# Technical Bulletin

Subject: **Effective Range of Remote Control Locking/Unlocking  
Too Short**

Number: **03-03**

Model(s): **Touareg**

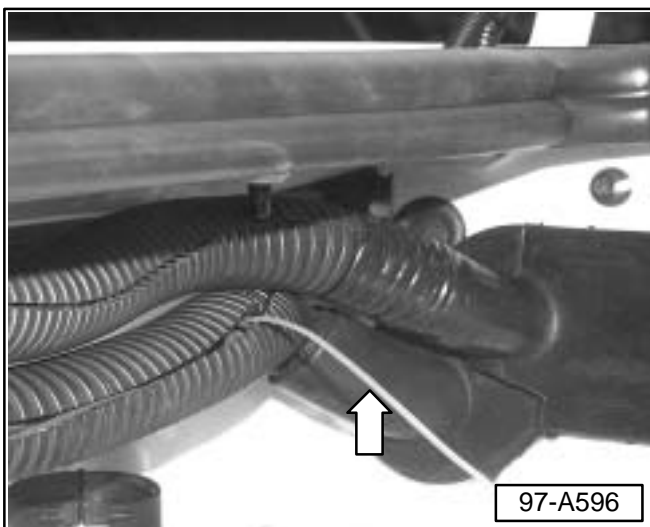
- ◀ – Open protective tubing from harness and pull antenna (arrow) gently through slit in tubing.

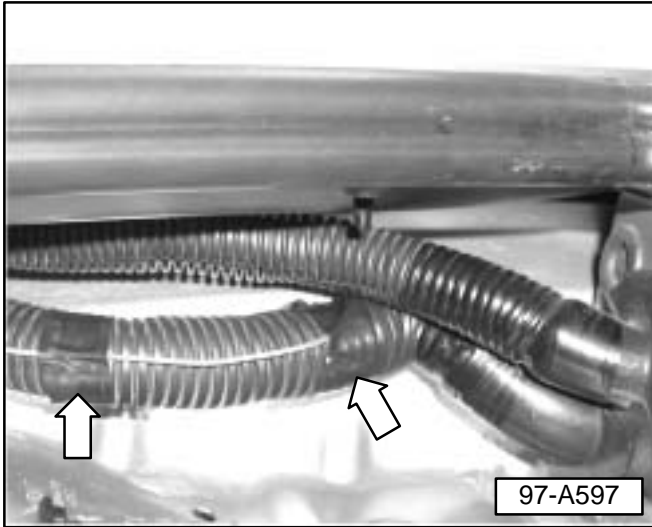
- ◀ – Fasten antenna wire with electrical tape to outside of tubing. Spot-tape in two positions (arrows). Do Not use cable-ties.
- Check remote locking/unlocking for improved operation distance.
- Reinstall removed components.
